INSTRUCTIONAL BULLETIN NO. 19-05

Regarding New and Revised Standard Drawings for Multimodal Design.

Effective August 9, 2019 letting (May 29, 2019 Turn-in), the following standard drawings have been developed to conform to AASHTO, "A policy on Geometric Design of Highways and Streets", 6th Edition, 2011, "Guide For The Development Of Bicycle Facilities", 2019, "Guide For The Planning, Design, and Operation Of Pedestrian Facilities" and TDOT – "Roadway Design Guidelines" Section 9, Multimodal Design.

STATE OF TENNESSEE
 STANDARD DRAWING
 DEPARTMENT OF TRANSPORTATION
 DETAILS OF STANDARD CONCRETE DRIVEWAYS

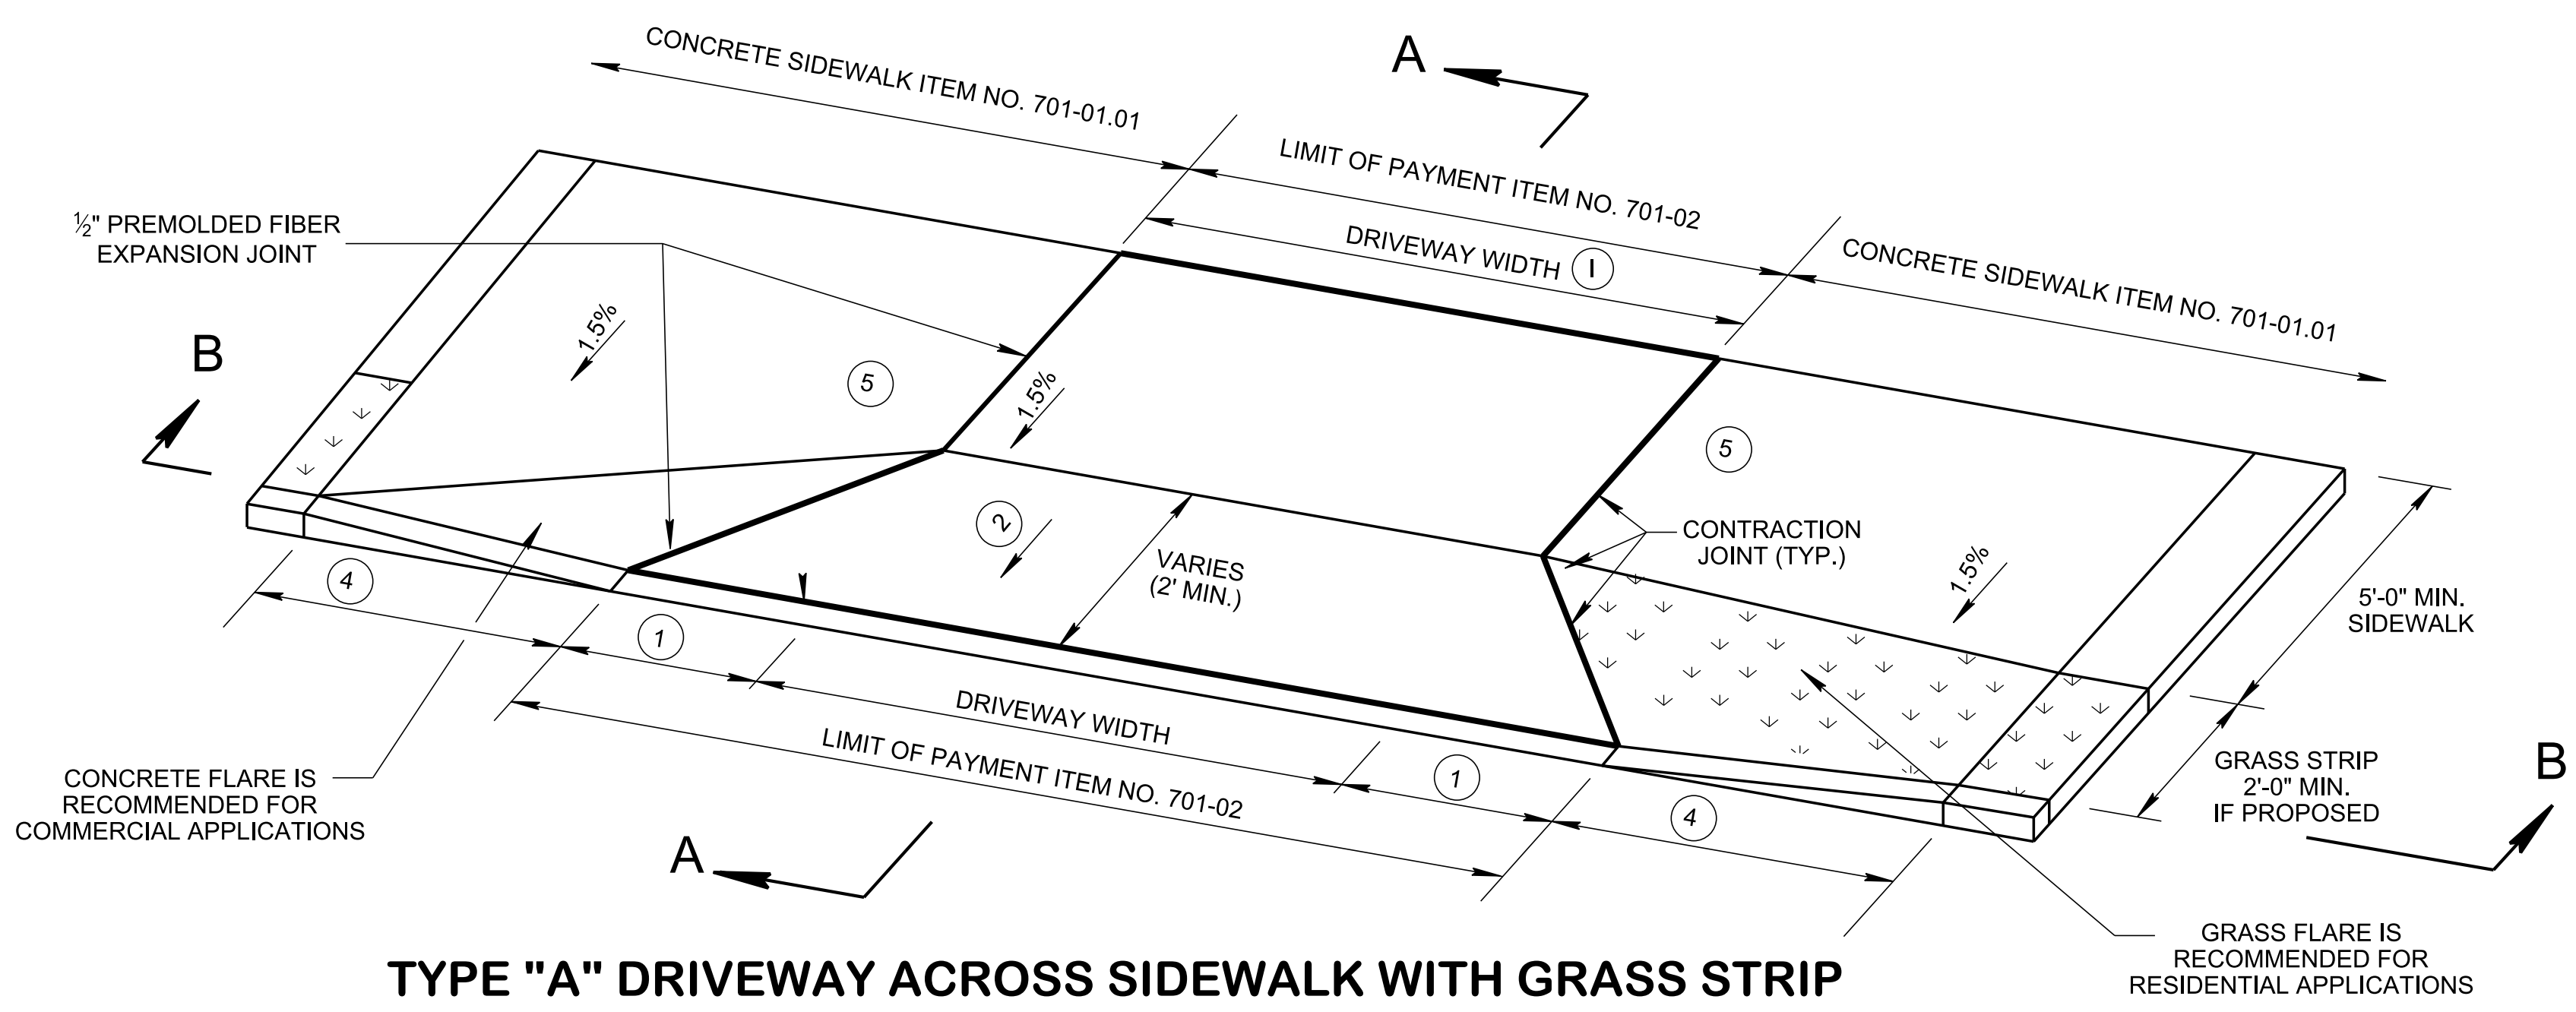
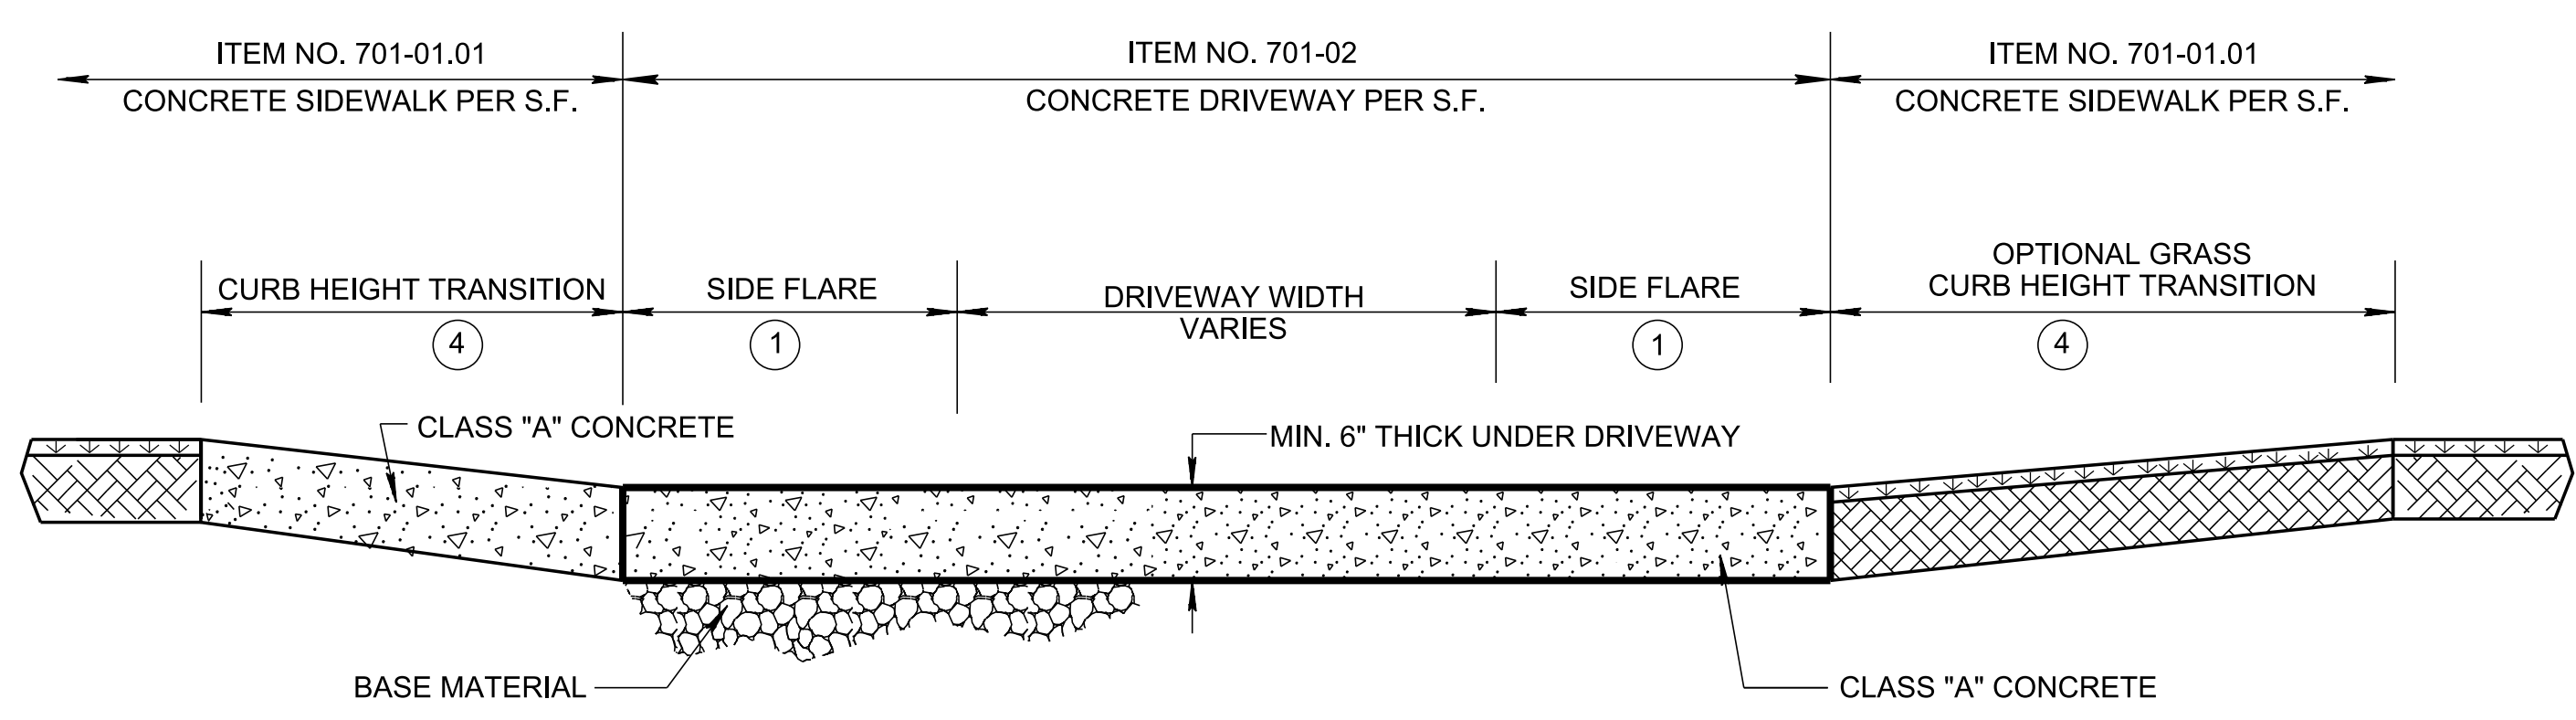
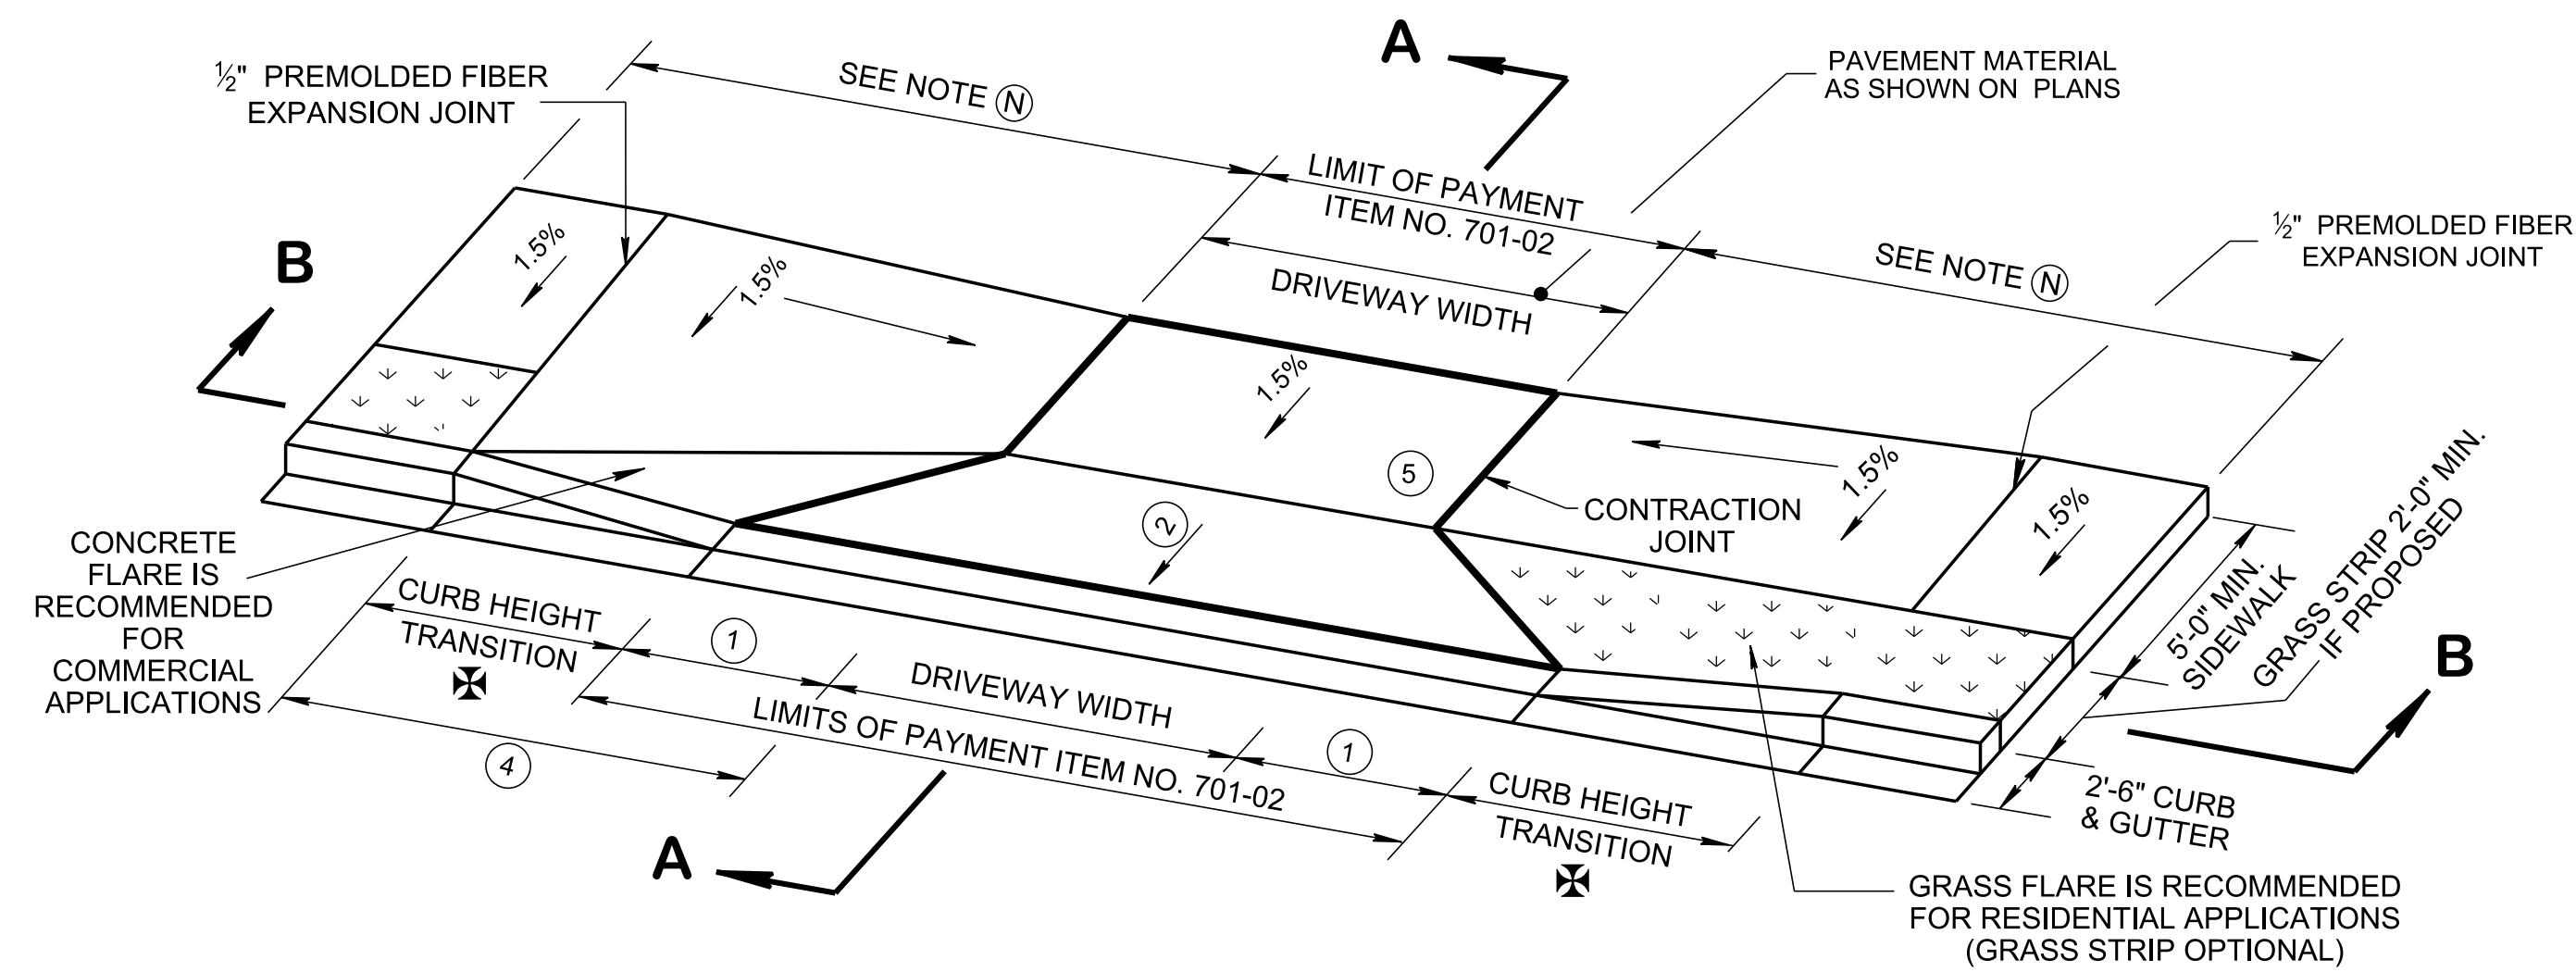
REV. 7-15-08: UPDATED SIDEWALK DIMENSIONS.
 REV. 4-8-16: ADDED ITEM NUMBERS. UPDATED SLOPES AND DIMENSIONS. UPDATED NOTES.
 REV. 07-16-18: ADDED NOTES TO CONC. FLARE AND GRASS FLARE IN ISOMETRIC VIEW. ADDED GENERAL NOTE (K). CHANGED REFERENCED STD. DWG. FROM RP-NMC-10 TO RP-VC-10. ADDED NOTE (A) AND RENUMBERED THE REST. ADDED SPECIAL NOTE. REDREW SHEET.
 REV. 01-07-19: CORRECTED SPELLING. REDREW SHEET.
